# **Monitoring Report MY05**

**Cedar Branch Restoration Site  
Monitoring Year 05  
DMS Contract 6598  
DMS Project Number 97009  
RFP#16-006313 (Issue Date: January 21, 2015)**

**MEMORANDUM**

Subject: Cedar Branch Stream Restoration Site  
MY-05 Monitoring Report Comments  
Yadkin River Basin CU 03040103  
Randolph County, North Carolina  
NCDMS Project # 97009  
Contract # 006598

### Cedar Branch Restoration Site Hydrograph T1 Stream Flow Gauge

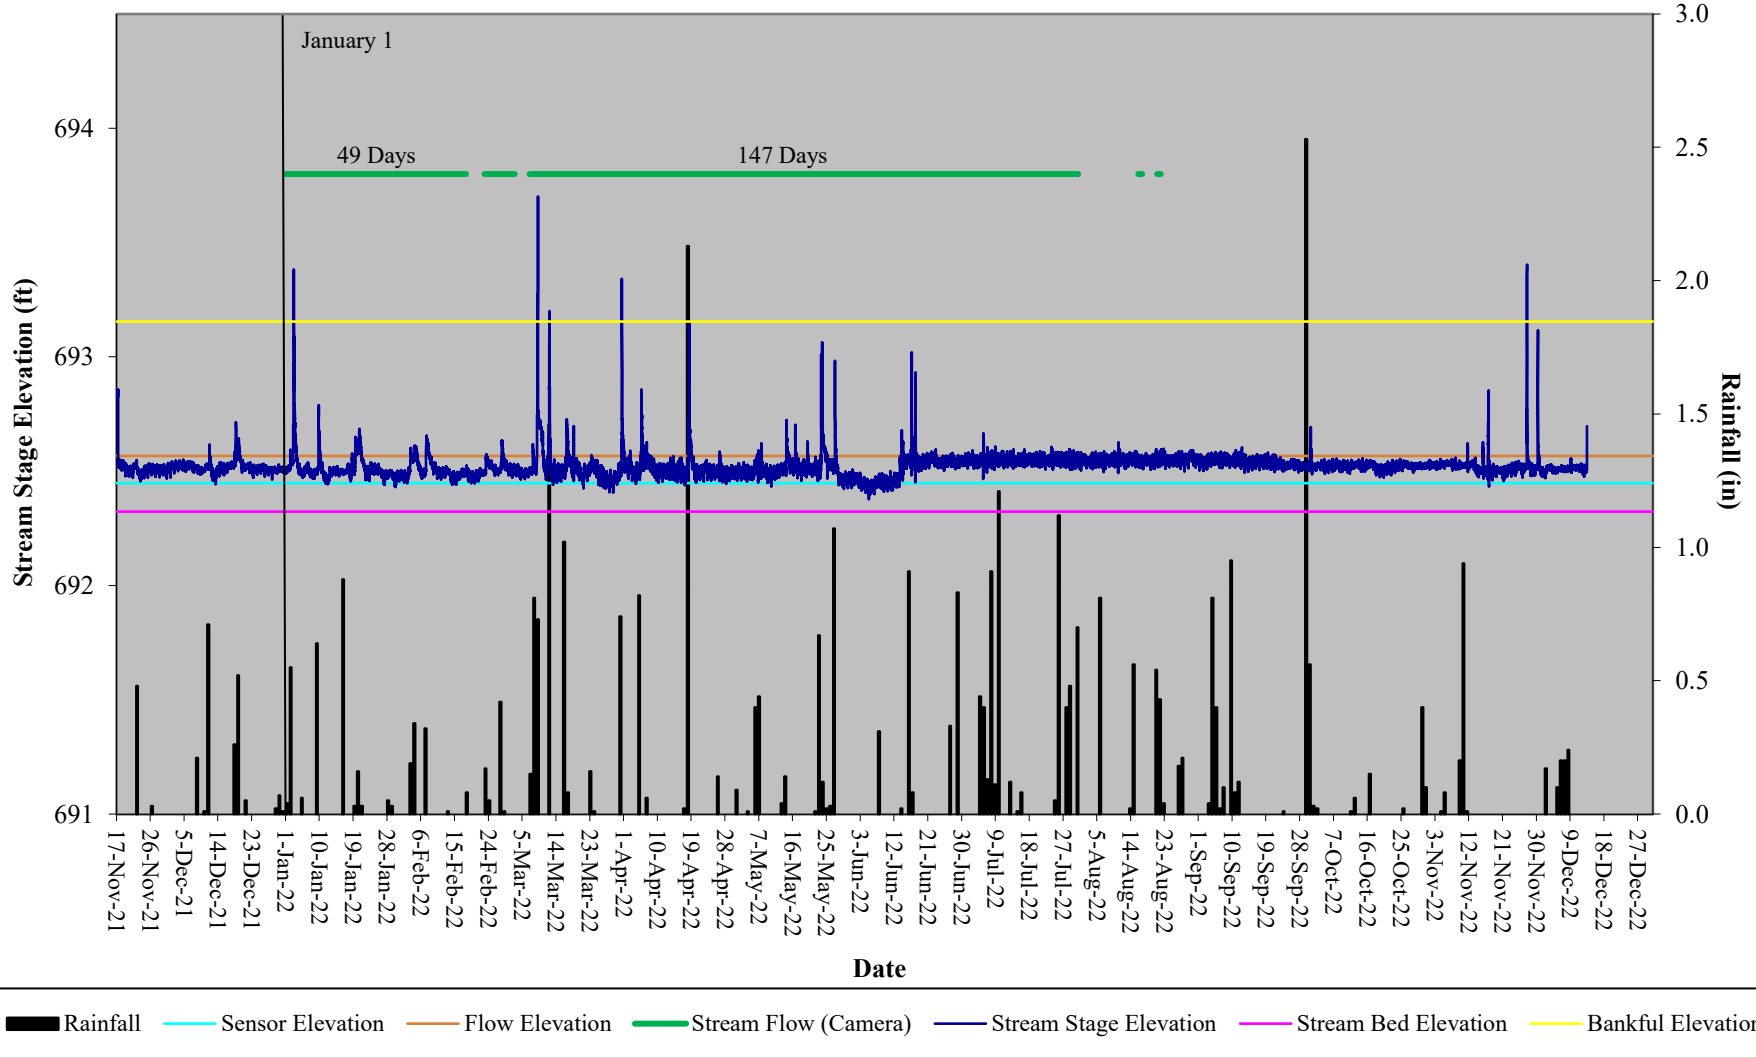
T1, T1-1 and T3 Stream Flow Graphs: Please add the max consecutive day information for both the camera and gauge similar to how the “49 Days” is shown on the T3 stream flow graph.

➤ *This change has been made.*
